Form C-103
May 27, 2004

SUNDRY NOTICES AND REPORTS ON WELLS

OXY USA Inc. - Current
Monsanto State #6
API No. 30-025-20907

OXY USA Inc. - Proposed
Monsanto State #6
API No. 30-025-20907

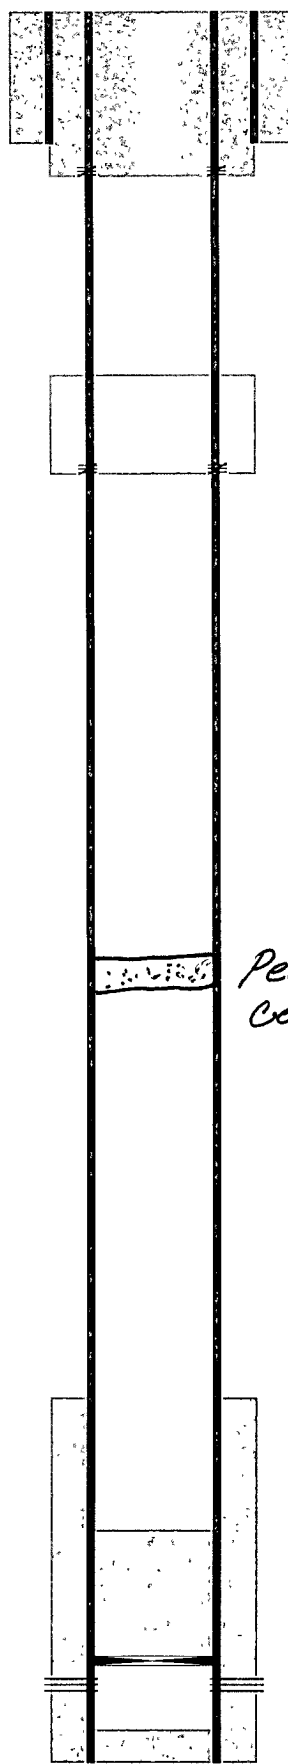
*Perf & Squeeze 50' in and 50' out
Cement @ 2400' TAG*

*1a. Perf & Squeeze cement 50' in & 50'
out @ 2400' TAG*
